## DESIGN REVIEW BOARD

DRB2016-09

Design Review for a Marriott Hotel as Phase I of West Bank Landing

#### WEST BANK LANDING-PHASE I: MARRIOTT SPRINGHILL SUITES-3RD ST NW

SITE PLAN LANDSCAPING PLAN BUILDING ELEVATIONS COLOR AND MATERIAL PALETTE TRASH ENCLOSURE DETAIL PHOTOMETRIC LIGHTING PLAN SIGNAGE EXAMPLES

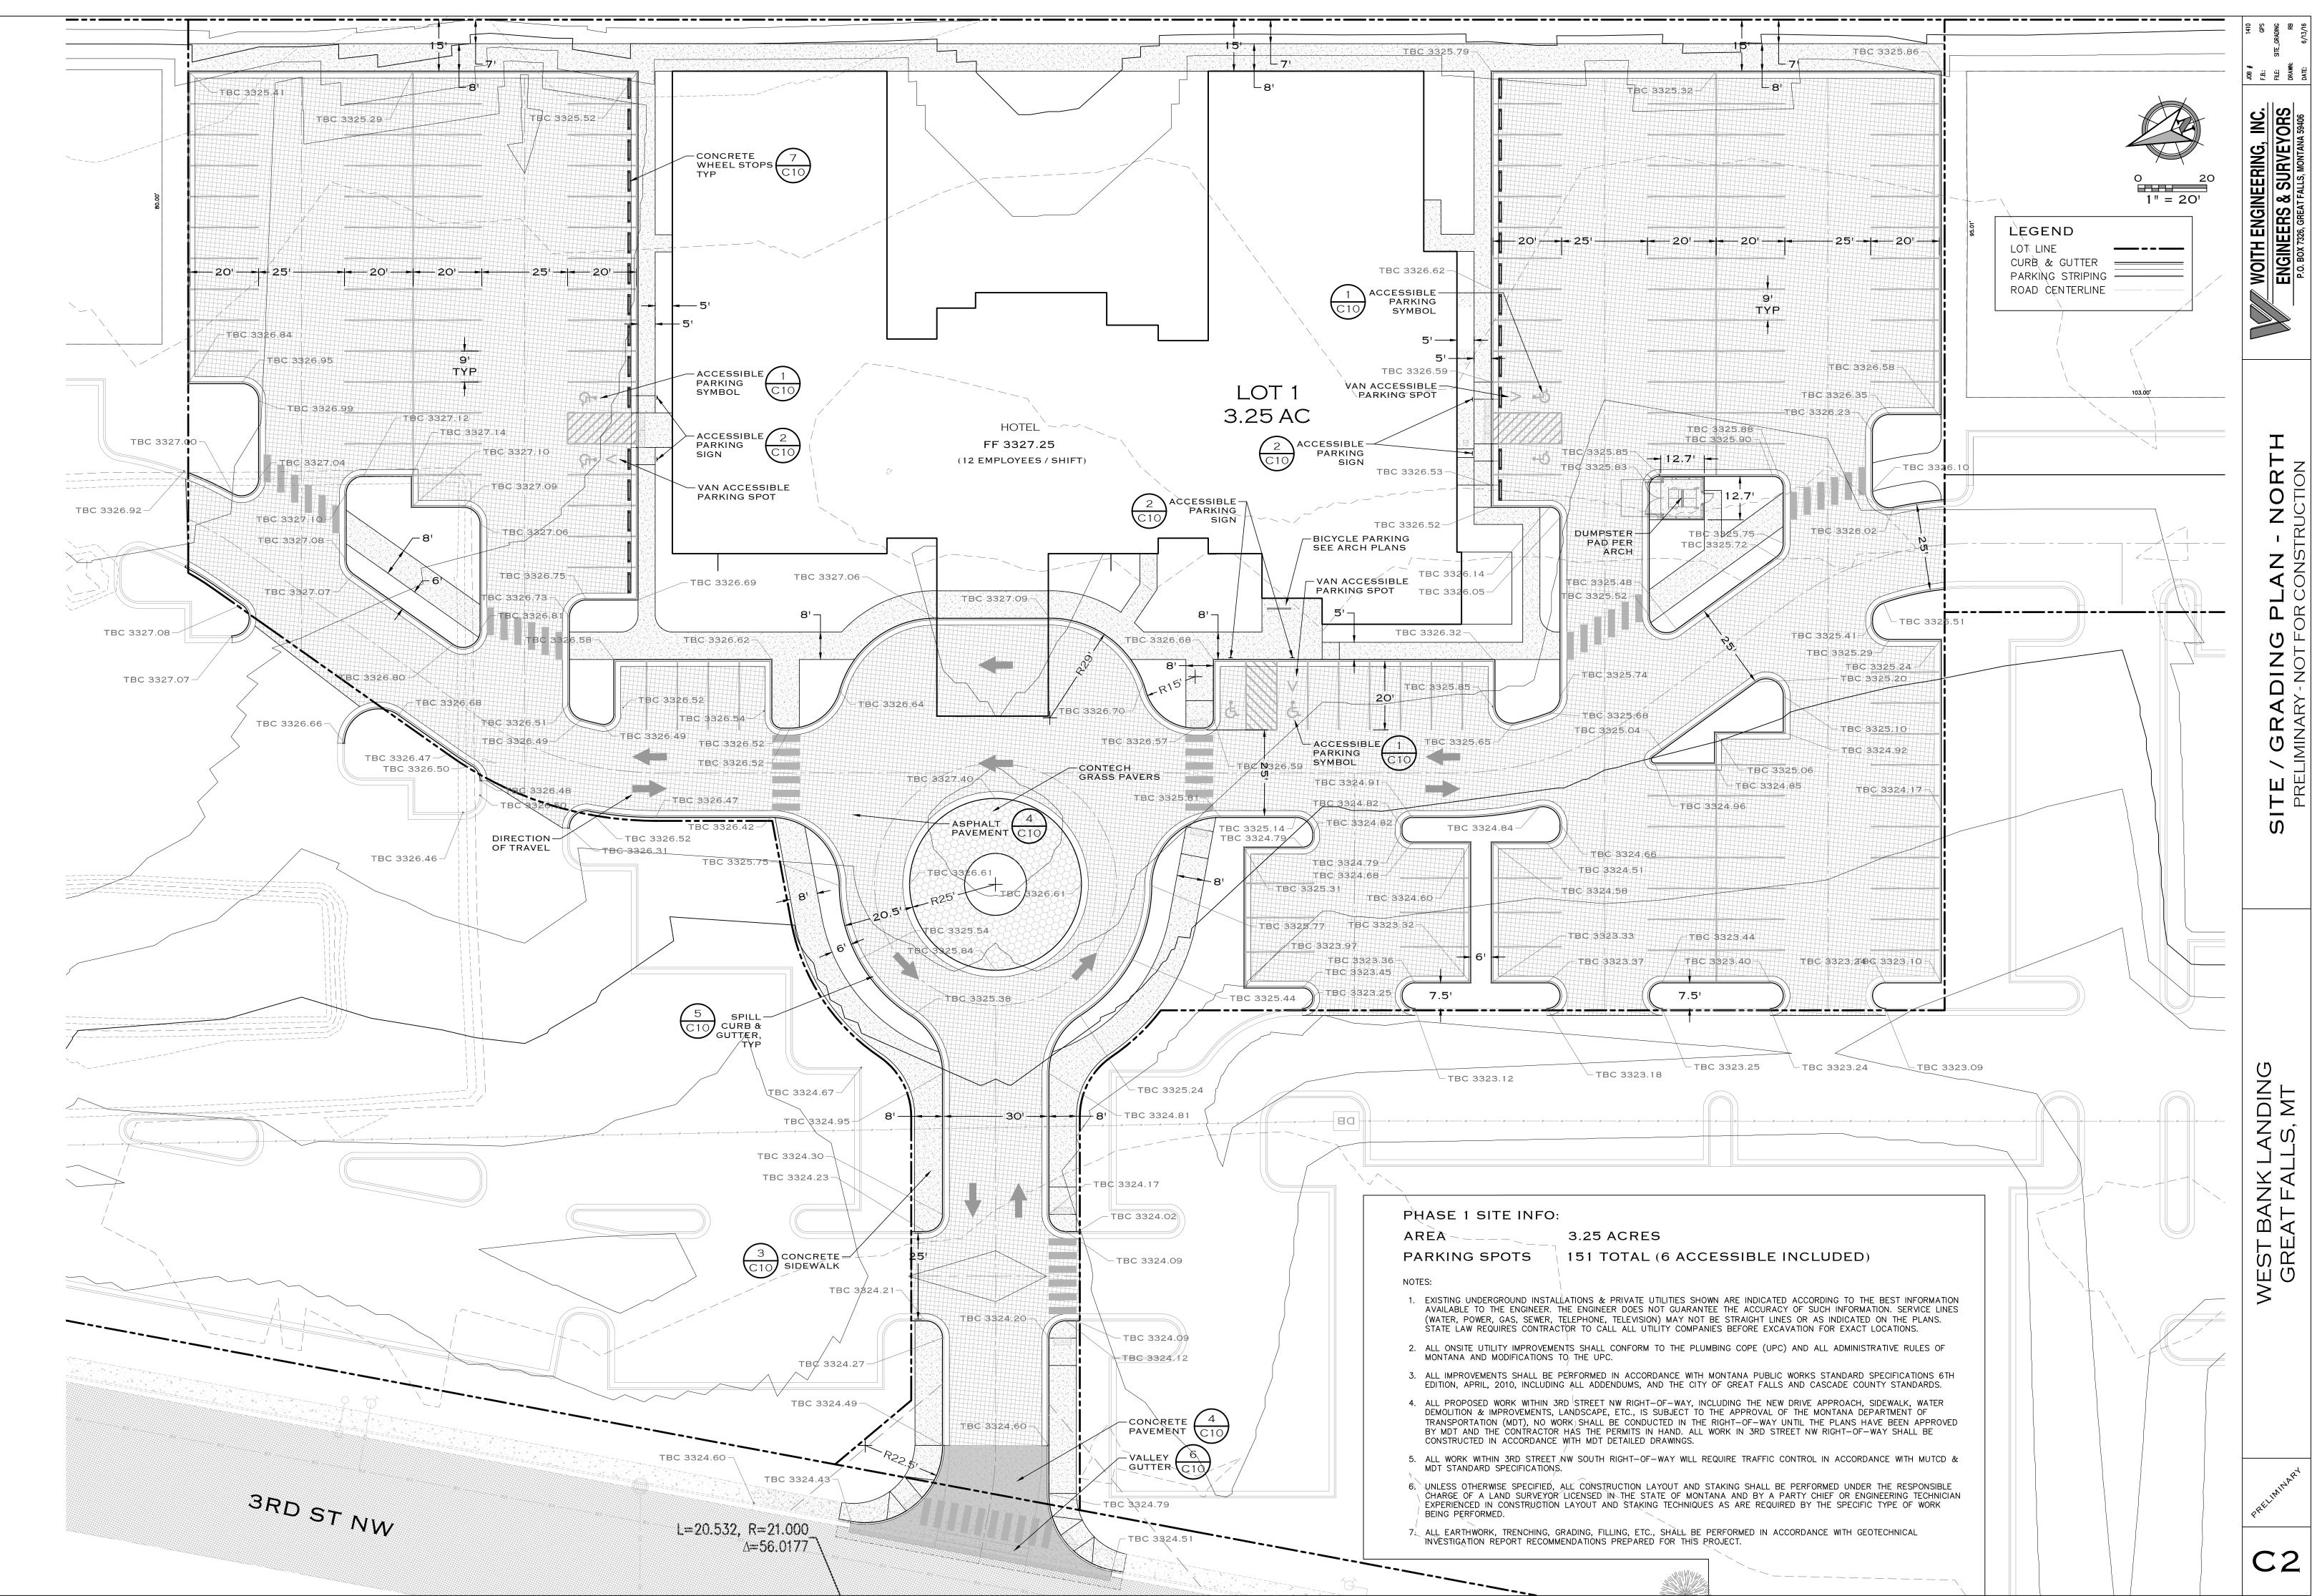
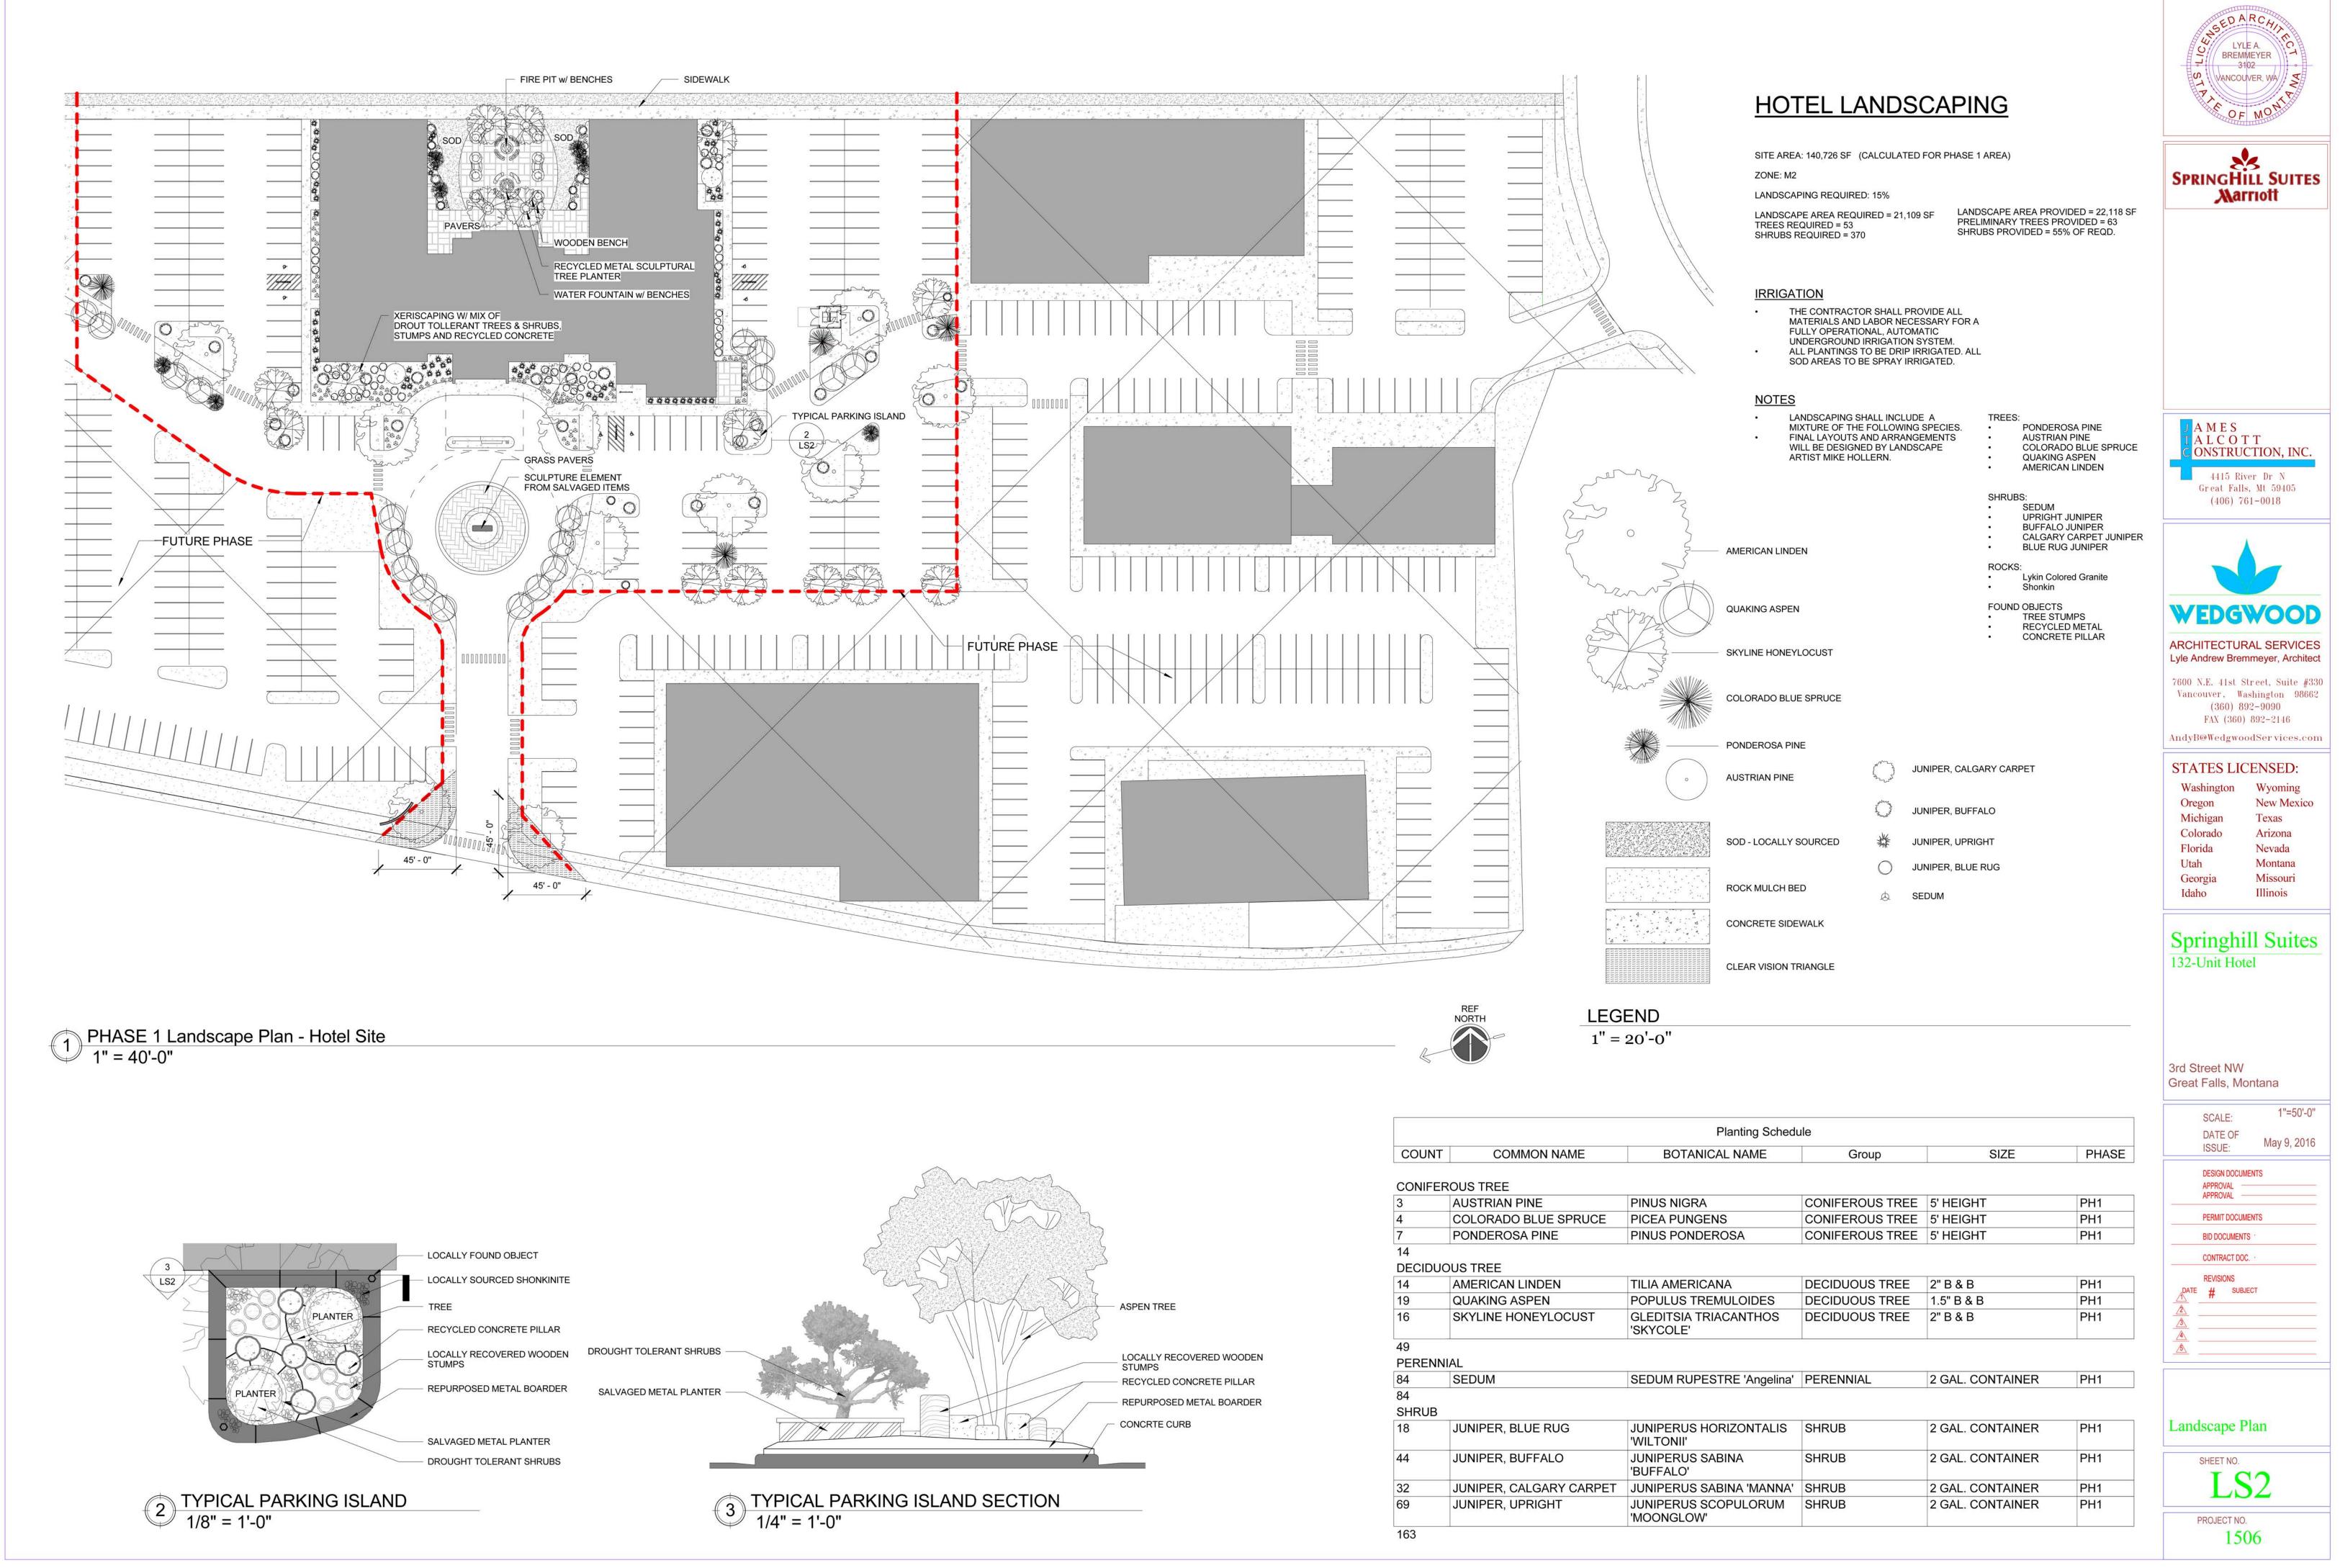
The proposed landscaping requires modification to meet the minimum requirements of the OCCGF. Paved or nonliving surfaces are the dominant texture within the interior of the site, with cement walkways surrounding the building, asphalt parking and drive aisles throughout, and rock mulch in all landscape beds. The exterior of the site is proposed to be softened by landscaping including sod, landscape beds and canopy trees. The site will utilize different arrangements of plants, sculptures, and locally found objects such as tree stumps and recycled metal. The goal of the project is carry on the landscape theme from West Bank One, which includes The Front, Staybridge Suites and Kobe Steakhouse restaurant, into West Bank Landing, with the help of landscape artist Mike Hollern.

The OCCGF requires that each row of parking must be terminated with a landscape island as per §17.44.3.030. The parking lots to the north of the hotel and south of the hotel are not terminated. Staff requires that the applicant revise the landscape plan to show islands to terminate the parking and add additional area for safer maneuvering for the last parking spots.

The OCCGF Chapter 44 – Landscaping, requires a minimum of fifteen percent of the gross property area to be designated as interior landscaping. The interior landscaping is to be inclusive of landscaping in vehicular use areas and foundation planting areas. The Phase I site plan request requires 21,109 square feet of interior landscaping. The OCCGF further requires one (1) tree and seven (7) shrubs planted and maintained per four hundred (400) square feet, or fraction thereof, of required interior landscaping. For this site, there are 53 interior trees and 371 shrubs required to be installed. The landscaping plan submitted does not meet the required rate of planting for shrubs.

- D. The applicant shall revise the outdoor lighting plan to meet the requirements of Chapter 40 as well as the recommendations of Staff.
- E. The applicant shall continue to work with staff to revise the landscape plan to finalize counts based on the Design Waiver and plant species.
- F. The applicant shall terminate each row of parking with a landscape island and turn around areas as per §17.44.3.030.
- 2. Chairman calls for a second, discussion, inquiries from the public, and calls the vote.
- CC Dave Dobbs, City Engineering
  Patty Cadwell, Neighborhood Council Coordinator
  Todd Seymanski, City Forester
  Aaron Perry, James Talcott Construction, representative, <u>aperry@jtc-mt.com</u>
  Spencer Woith, Woith Engineering Inc., representative, <u>spencer@woitheng.com</u>
  Timothy Peterson, LPW Architecture, representative, <u>timothyp@lpwarchitecture.com</u>
